Introduction: Project Background

- Location 515 Westlake Avenue N.
500 9th Avenue N.
- SLU Street and Open Space Context The block is bounded by Westlake Avenue N., Mercer Street, 9th Avenue N. and Republican Street and is located one block south of Lake Union.

EDG 6 June 2012

Summary of Priorities & Board Recommendations

Westlake Avenue Streetscape

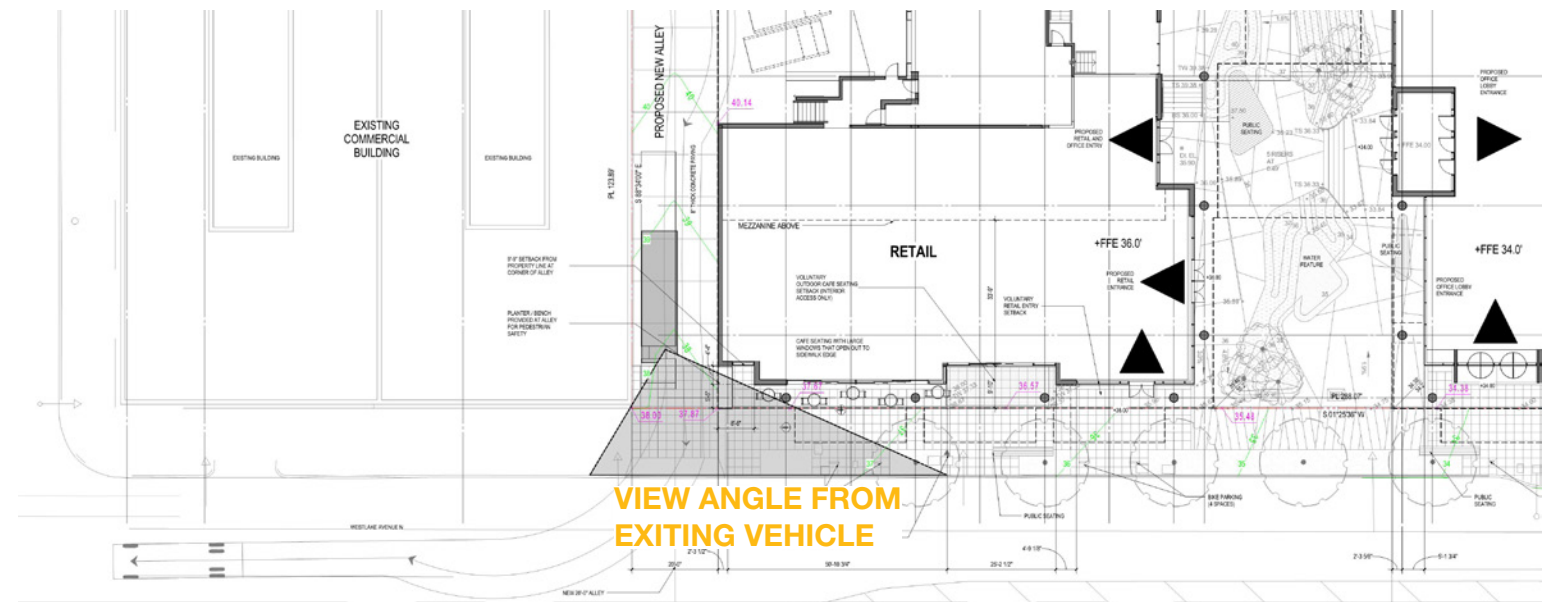
- At the Recommendation meeting, the applicant will need to demonstrate adequate vehicular exiting at alley exit to Westlake and create pedestrian safety (mirrors, paving changes, etc.) (A-4, A-8, D-8)
- The Westlake street frontage should be designed to maximize human activity, retail street frontage, and pedestrian safety (A-2, A-4)

Westlake street frontage is activated by Retail and lobby uses. The alley connection has been designed to achieve clear sightlines while signaling the end of the pedestrian zone. A new integrated Streetcar waiting and ticket station will be incorporated.

- The southern corner of the Retail frontage has been set back approximately 10 feet, extending the public realm at the sidewalk and opening view angles for vehicles exiting onto Westlake Ave. N.
- The alley is the minimum dimension allowed by SDOT and is intended to serve as an exit for the loading area and not as an exit for automobiles exiting the parking garage.

3. 9th Ave N frontage:

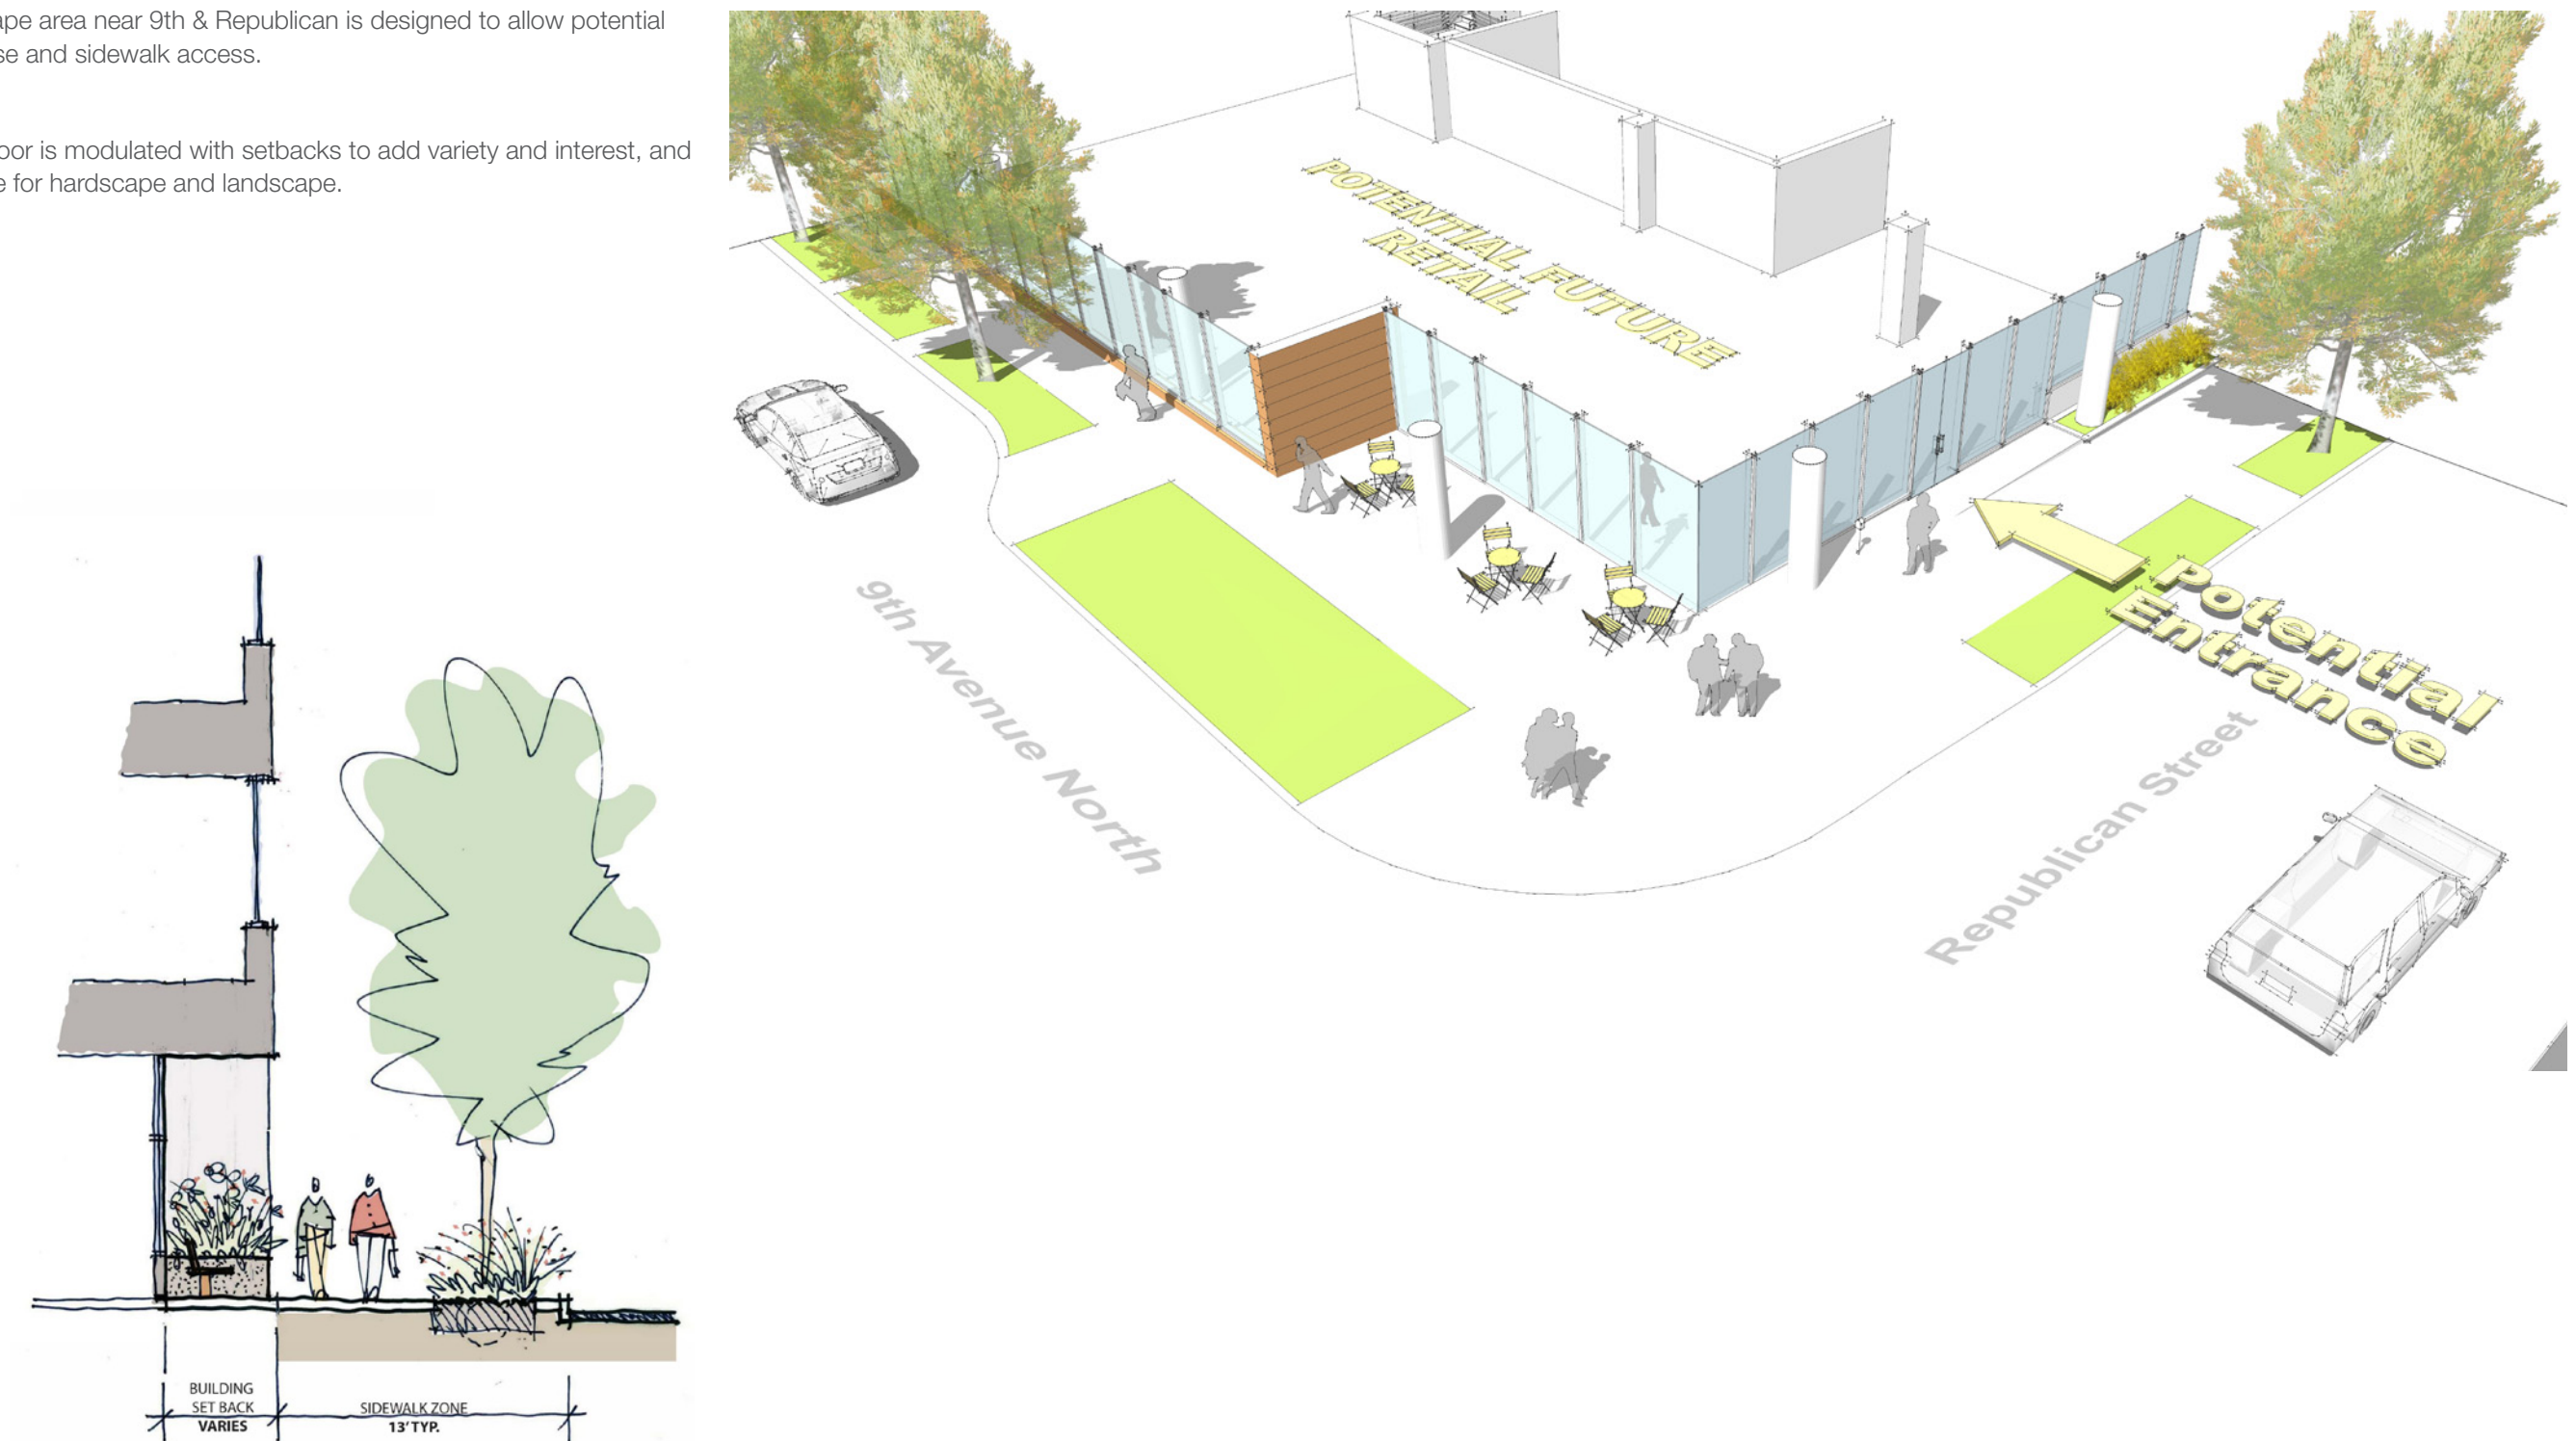
- The design of this façade needs to include significant design moves to break down the appearance of the long façade and to respond to the human scale. (B-1, A-4, C-3)
- This street frontage should be designed to enhance human activity at the street level. The applicant needs to clearly demonstrate how the proposed street level building program on 9th Ave N will meet this guidance. (A-4)

- The Streetscape area near 9th & Republican is designed to allow potential future retail use and sidewalk access.
- The ground floor is modulated with setbacks to add variety and interest, and provide space for hardscape and landscape.

Pedestrian Galleria
From Westlake Avenue N towards 9th Ave N

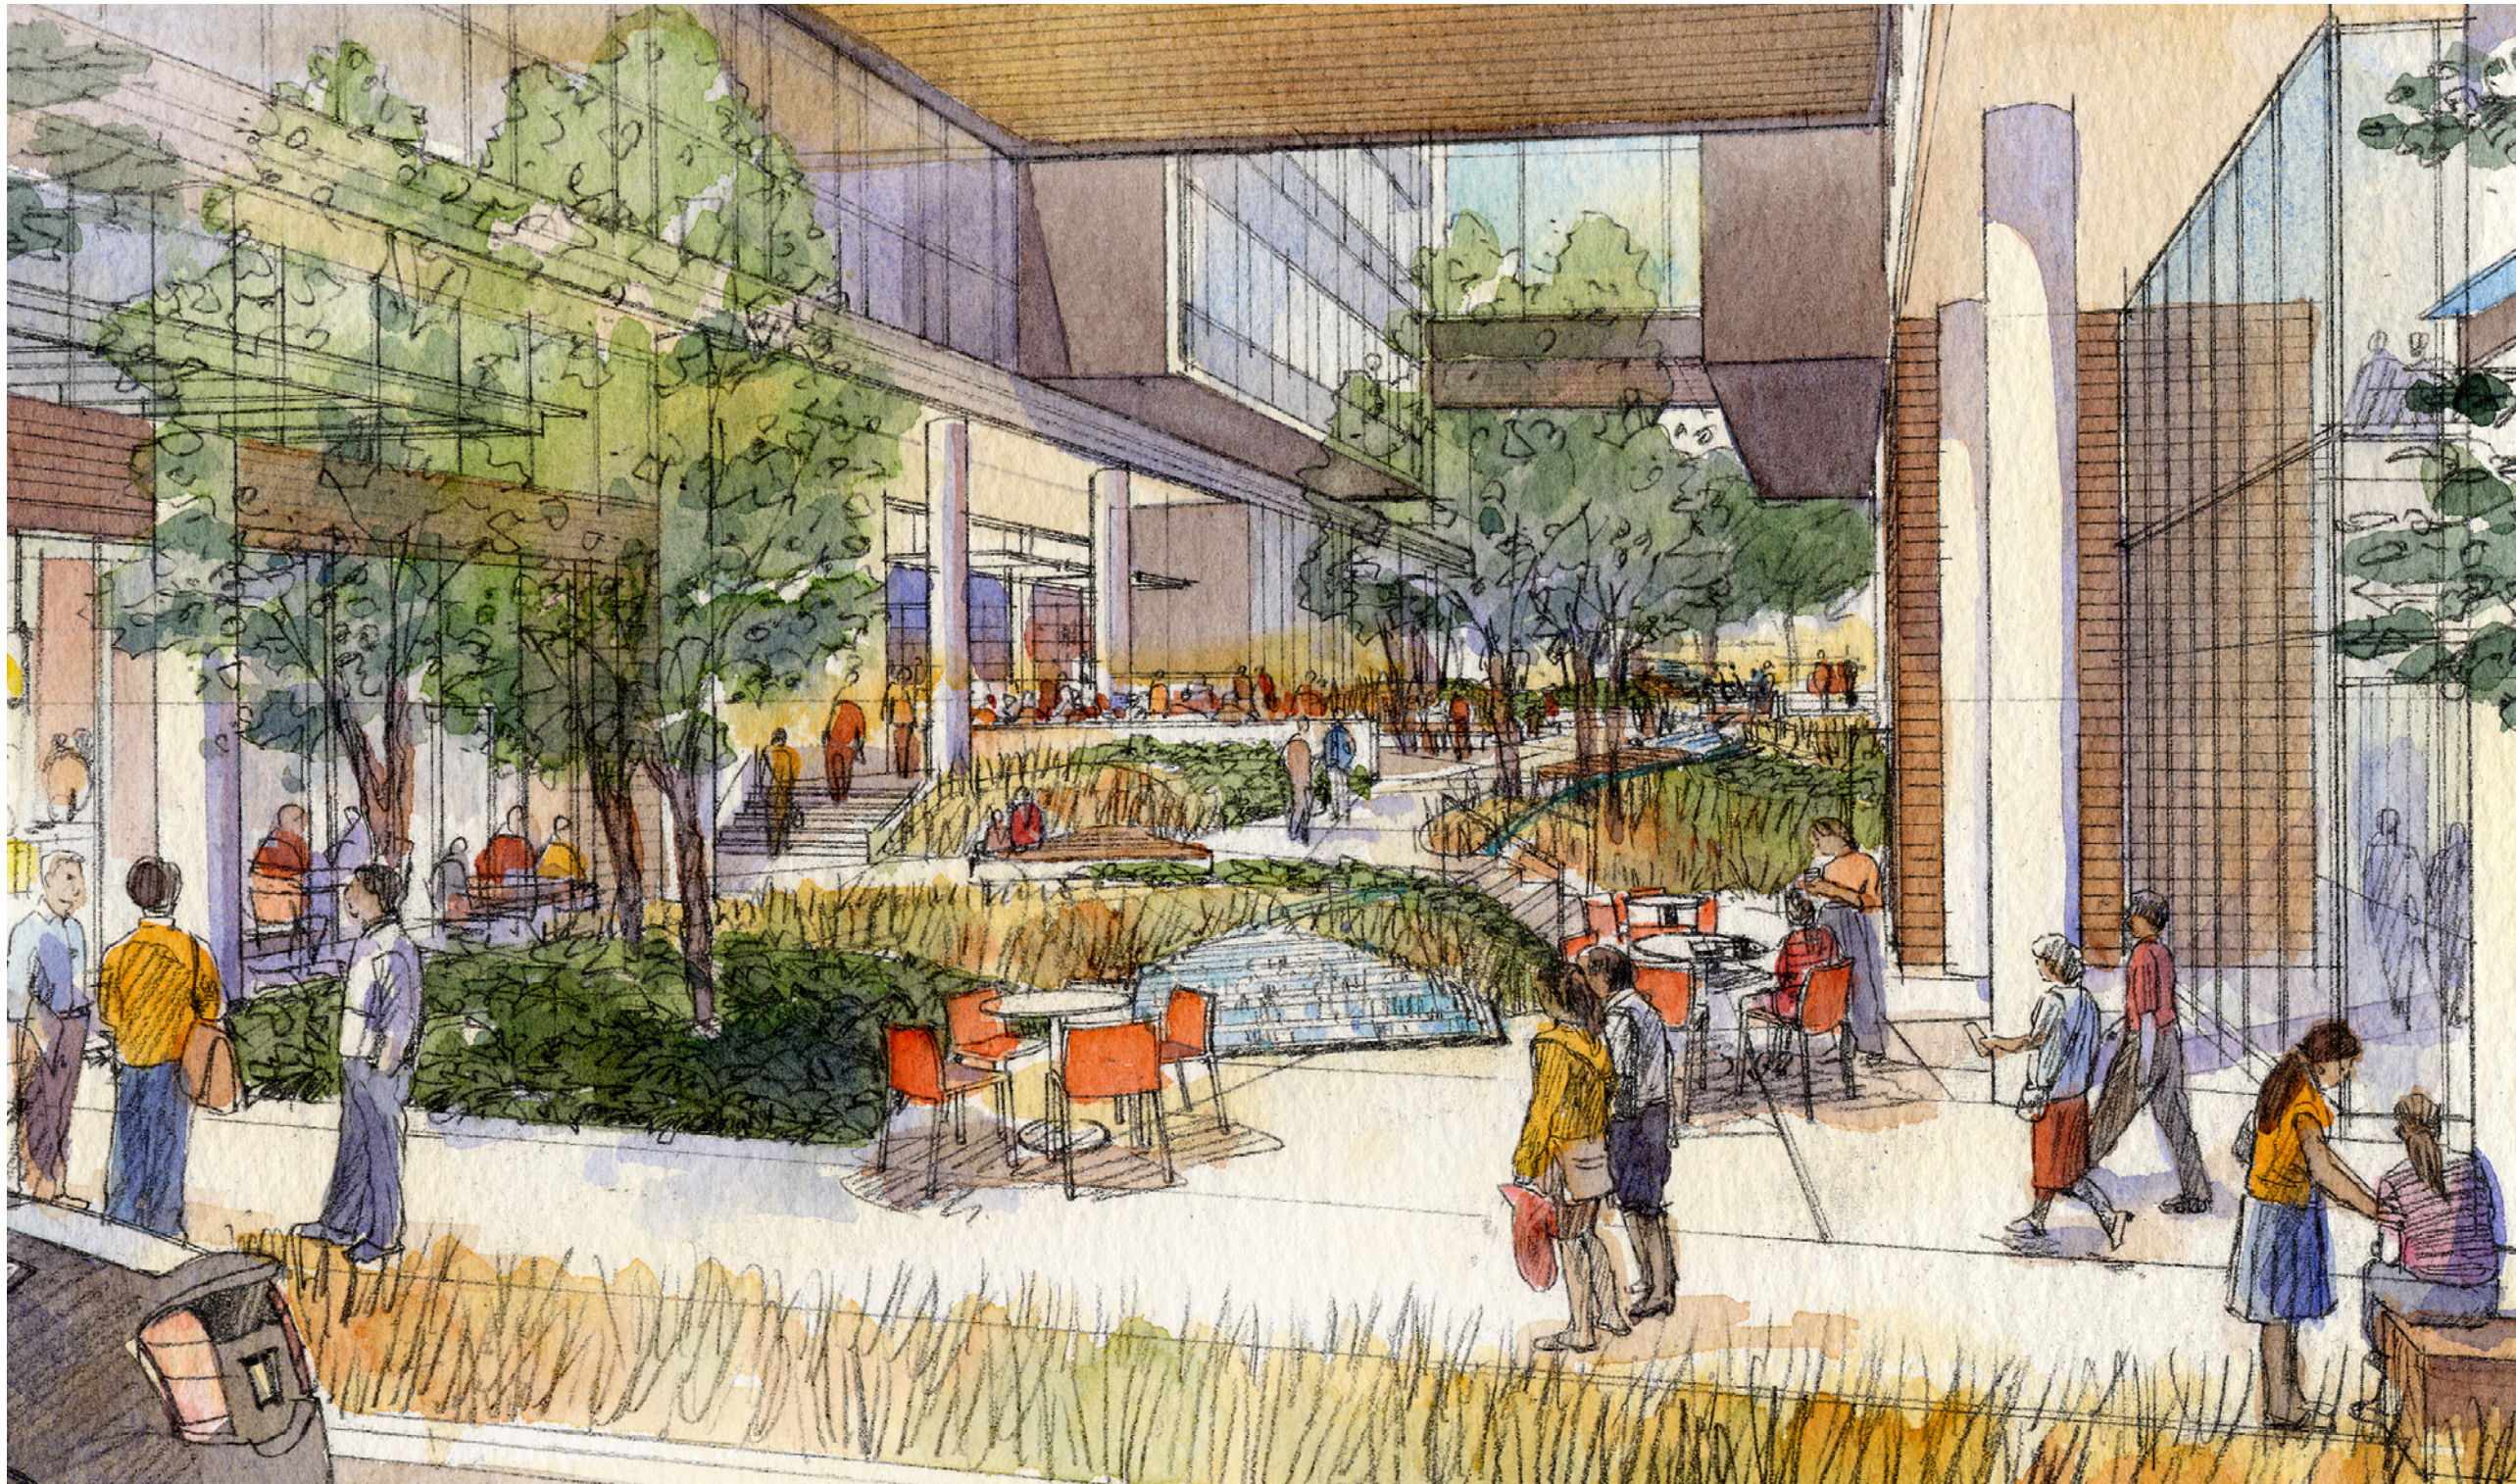
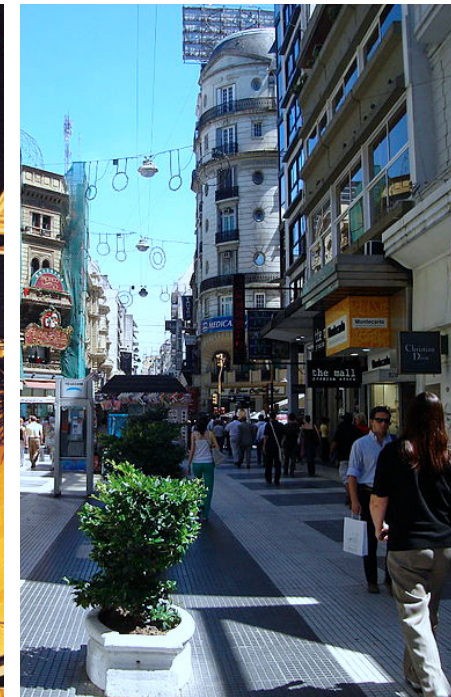
- The location and design should be designed to respond to the UW mid-block crossing to the west. (A-2, C-1, D-1)
- The Board would like to see a lighting plan at Recommendation stage, demonstrating the connection will be safe, well lit, and include maximum natural lighting with supplementary lighting strategies as needed. (D-1, D-7, D-10)

- Orientation of retail to the pedestrian connection is problematic; consider using the retail spaces to activate the street frontages and draw people into the midblock crossing. (A-2, A-4, D-1)

- The corners of the building adjacent to the west end of the crossing should be eroded to enhance the connection with the UW Medicine mid-block crossing to the west. Consider transparent corners in this location. (A-4, D-1)

- The crossing should be designed to clearly appear public and not a private courtyard. (A-4, D-1)
- Design the connection to minimize wind tunnel effects and maximize pedestrian comfort. (D-1)
